**King's Mark
Environmental
Review
Team
Report**

**STONEBROOK
SUBDIVISION
COLEBROOK,
CONNECTICUT**

Environmental Review Team Report

Colebrook Inland Wetlands Commission

**PROPOSED
SECTION 1**

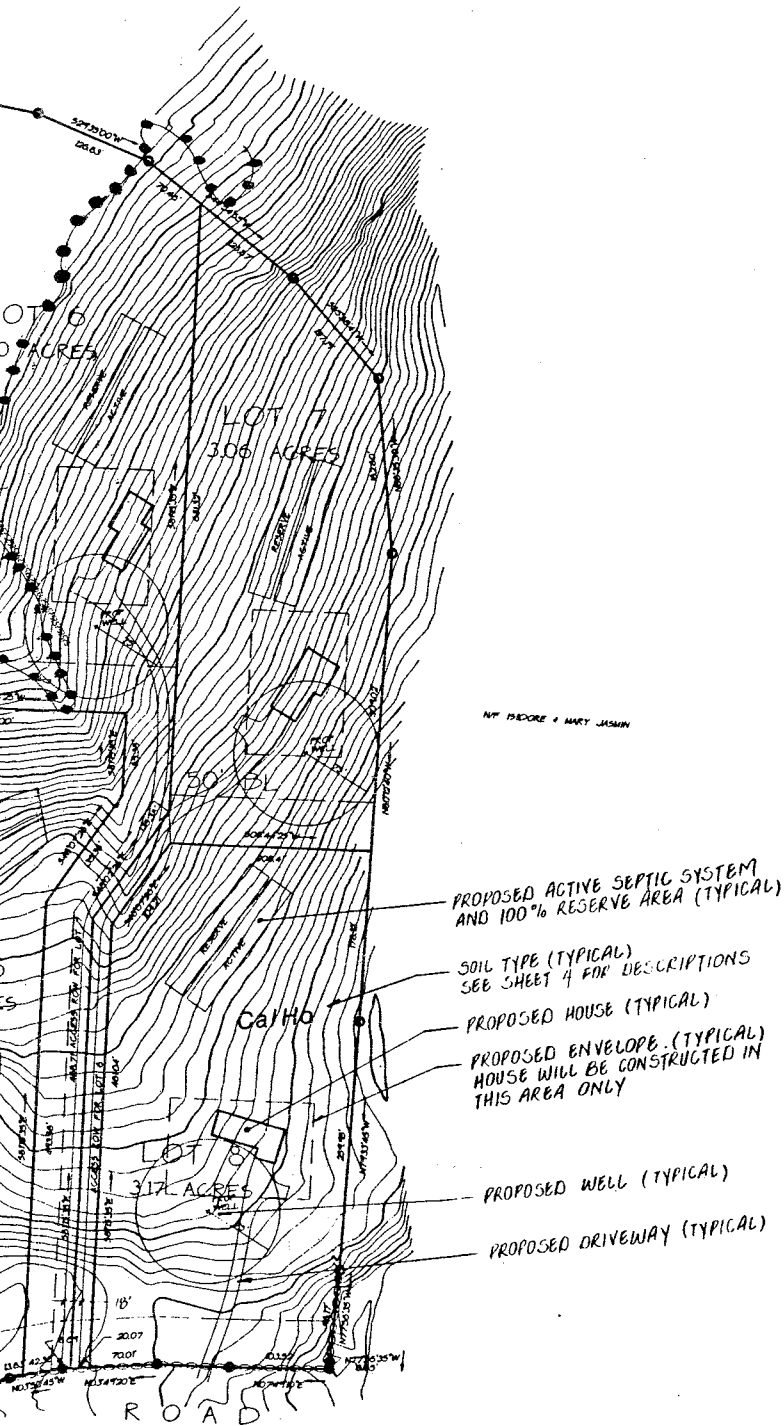
Section 1 is steeply sloped with little soil cover in the western part. Many of the septic systems are located considerable distances from the houses. Both the septic tank and the distribution lines must be constructed so that sewage will not leak onto the bedrock. The soils of the primary and reserve leaching fields appear to be suitable. Each of the lots will require detailed engineering design plans. One concern on Lot 3 is the stone wall which may serve as a conduit for groundwater. Lot 3 is wide enough so that the leaching fields can be moved to avoid the stone wall.

- 1) Lots which have shallow to bedrock conditions, generally 7 feet or less (Lots 2, 3, 4, 5 and 8 in Section 1).
- 2) Areas of moderate to steep slopes (mostly all of Section 1 and the central parts of Section 2).
- 3) The presence of till (hardpan) soils which have moderately slow percolation rates and elevated groundwater table. These two conditions result from the silty and more compact soil zone which develops below the rooted and surficial weathered zone.

Soils in each of the proposed primary and reserve leaching areas appear to be well suited for leaching purposes. Each of the 8 lots will require detailed engineering design plans be prepared due to the shallow depth to bedrock and potential for groundwater to be within 3 feet of existing grade. For that reason, it is highly probable that shallow leaching trench systems will be utilized, incorporating groundwater intercepting drains and some quantity of sandy fill material to assure trench bottoms are placed at least 18 inches above the compact glacial till. One other concern with respect to Lot 3 is the location of the stone wall which runs perpendicular to existing contours. In the past, stone walls have been known to intercept and carry subsurface groundwater flows, acting very much as a curtain drain. Fortunately, Lot 3 is wide enough so that the primary and reserve areas could possibly be located north of the wall and not require its disturbance or removal. It is highly probable that additional deep test pits and percolation tests will be performed with respect to individual designs of sewage disposal systems serving the proposed residences.

**PROPOSED
SECTION 2**

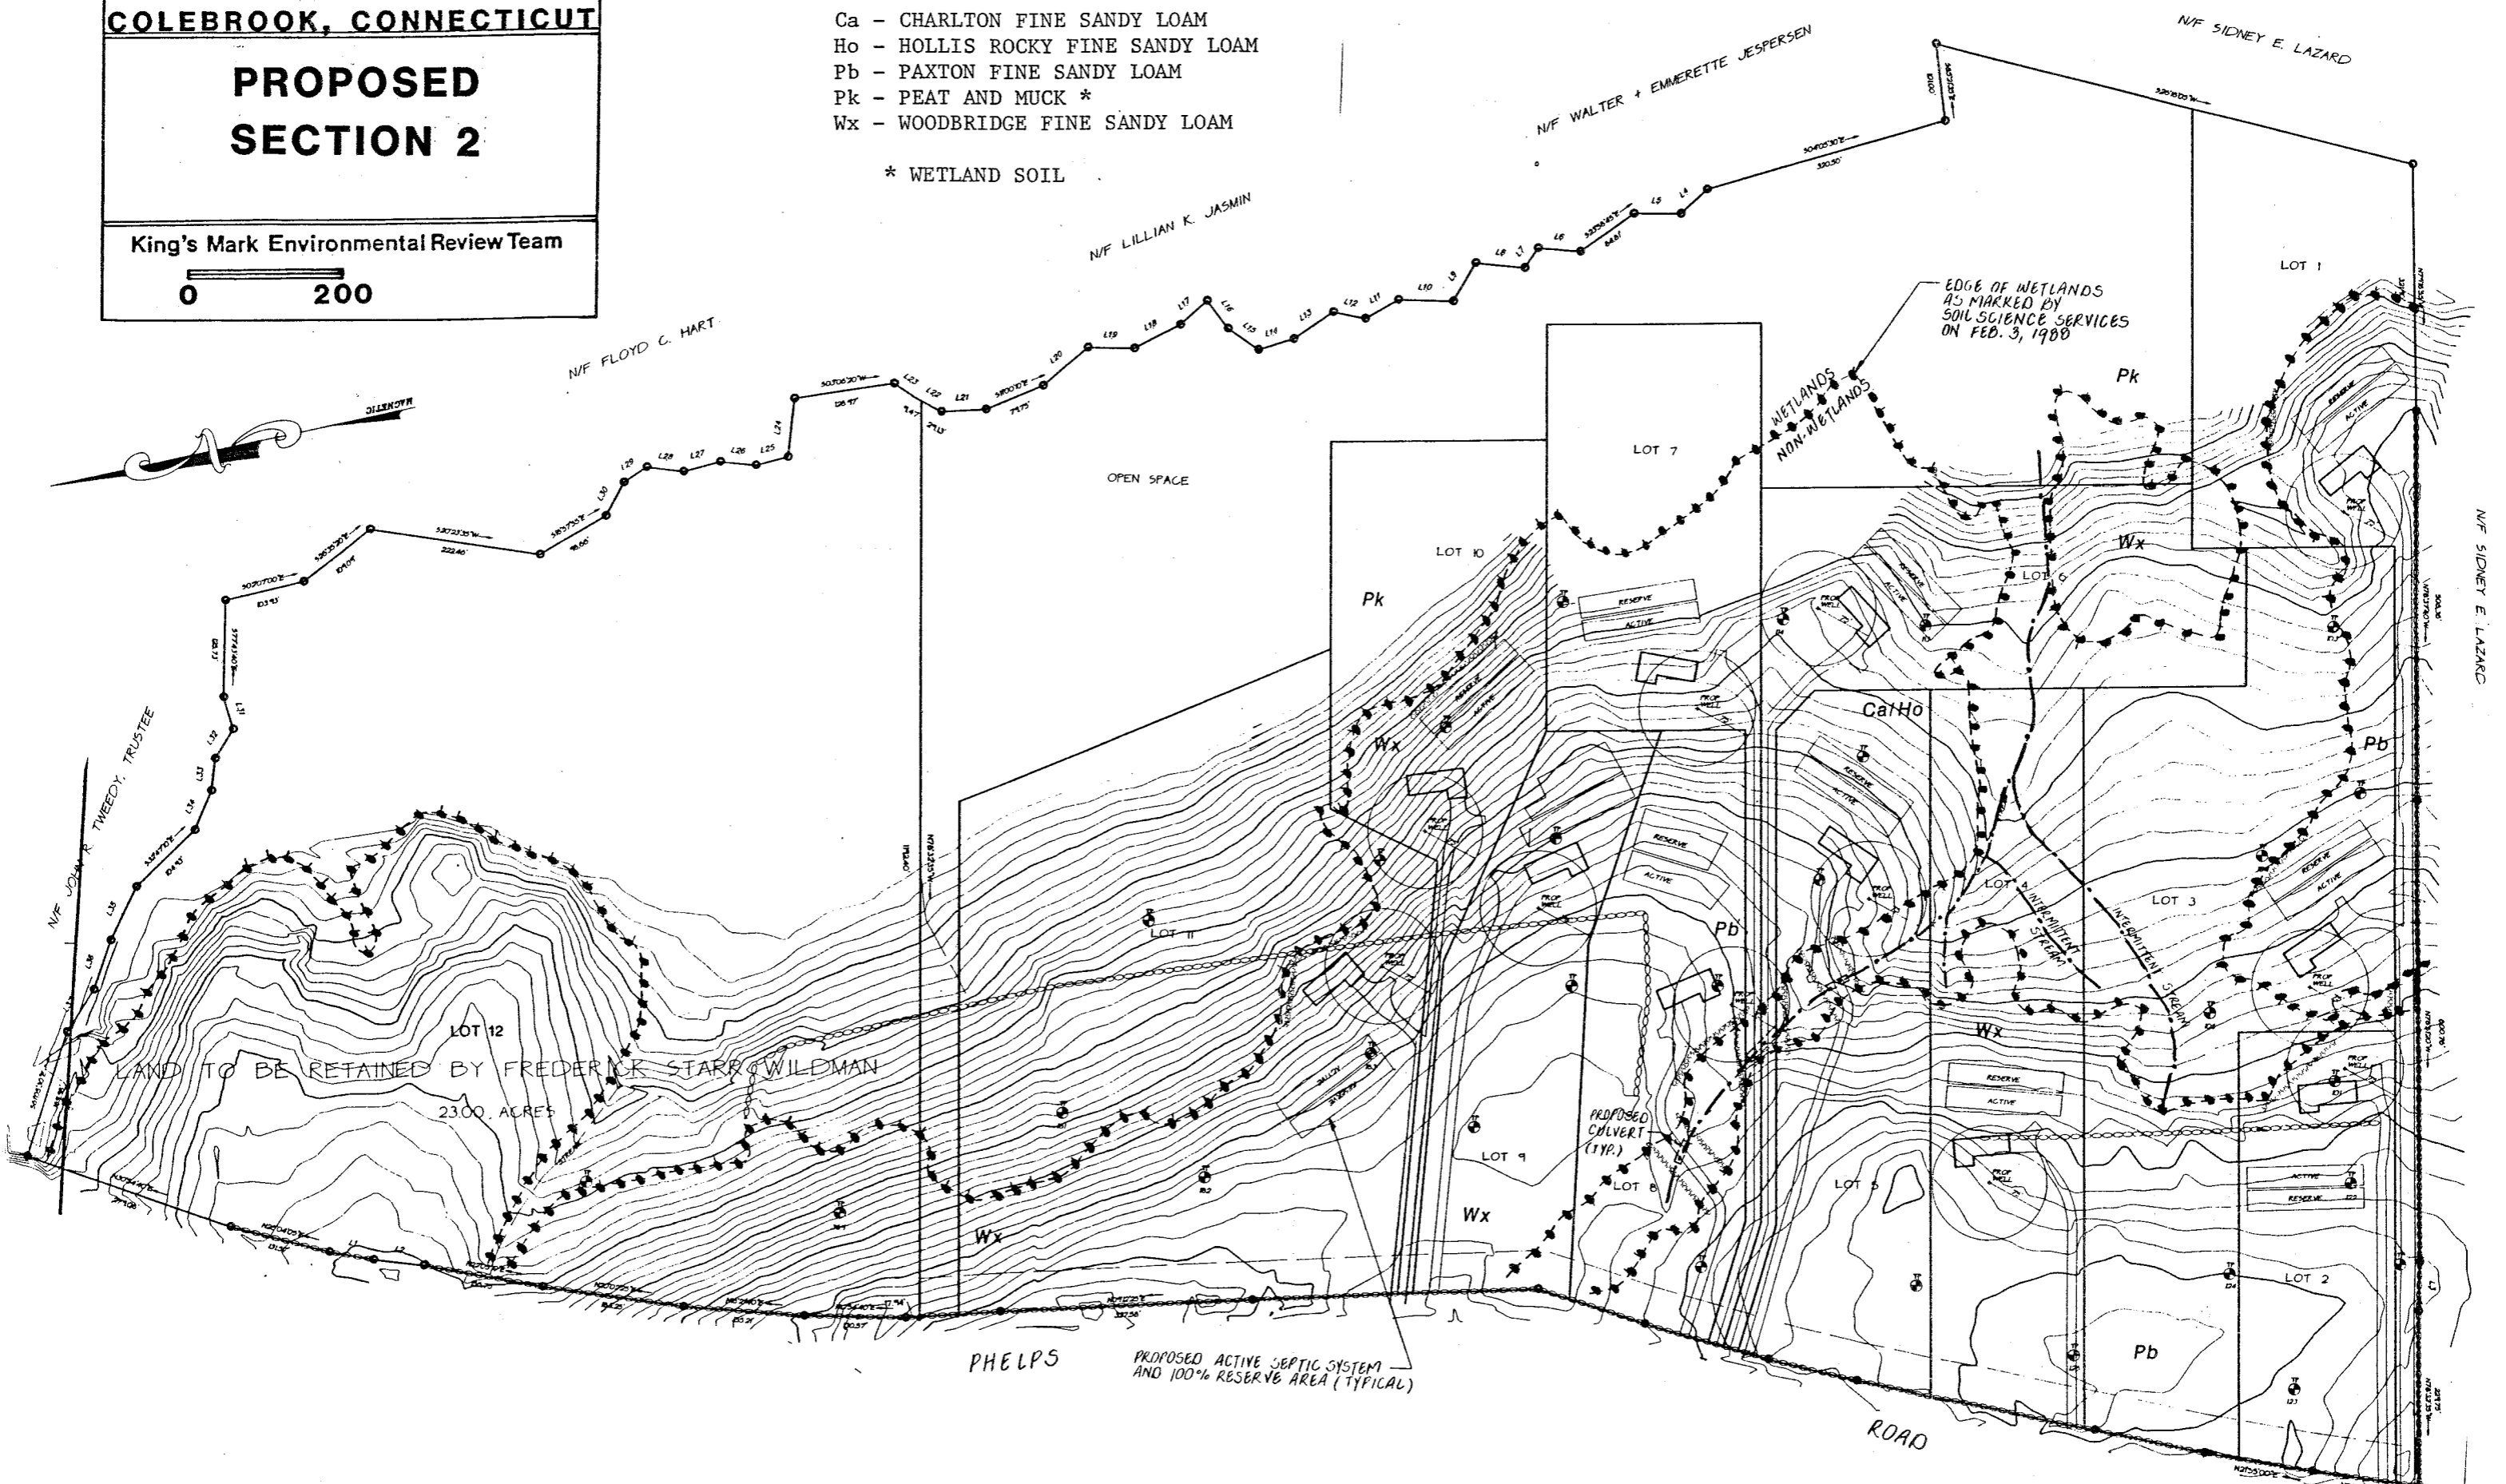
Section 2 does not have ledgerrock as the restrictive factor. The soils should be suitable for leaching fields. The major restrictive factor is the seasonal high groundwater and the proximity of the wetlands. Two of the houses will have the sewage pumped. Proper design of the septic systems should assure no adverse impacts to the wetlands. Detailed engineering plans will be required for many of the lots due to high groundwater level.

systems may be forced to enter the wetland causing unnecessary sedimentation. It is recommended that the Commission evaluate all possible alternatives to this proposal which include the following:

- 1) A reduction of the number of lots which would reduce the number of crossings required to access the property, and/or
- 2) Reducing the number of crossings from four to two. One crossing to access Lots 1, 2 and 3 and one combined crossing to provide access to lots 5, 6, 7 and 8.

- 3) The driveway layout for Section 2 is less than optimal due to the number of curb cuts in close proximity to one another. This presents a potentially unsafe situation where vehicles could conflict with one another in turning movements. A system of shared driveways, private roads or new town roads should be considered to improve the current plan. Shared driveways may be appropriate for Lots 1, 2 and 3, 5 and 6, 7 and 8. If Colebrook's zoning regulations were amended to provide for private dirt roads (e.g. through a special permit process where meaningful open space land was provided as a trade off), a private dirt road might be appropriate to service Lots 5, 6, 7 and 8. Use of a private dirt road might also be appropriate to service Lots 9, 10 and 11. Barring provisions for private dirt roads, consideration should be given to serving Lots 5, 6, 7 and 8 plus 9, 10 and 11 with paved private roads or local roads as provided for under Colebrook's subdivision regulations.

Based upon review of all of the information provided, each of the proposed 12 lots should be considered suitable with respect to minimum Public Health Code requirements for installation of a subsurface sewage disposal system. Due

to the groundwater elevations noted, each of the 12 lots would be classified as an area of special concern and require detailed engineering plans be prepared by a registered professional engineer. It is quite possible that designated leaching areas will be shifted slightly and that additional soil tests will be performed in order to identify the suitability of the final designated primary and reserve leaching areas. The engineering plans should also address the details and technical complexities of pumping effluent to higher leaching areas serving those residences on Lots 2 and 11.
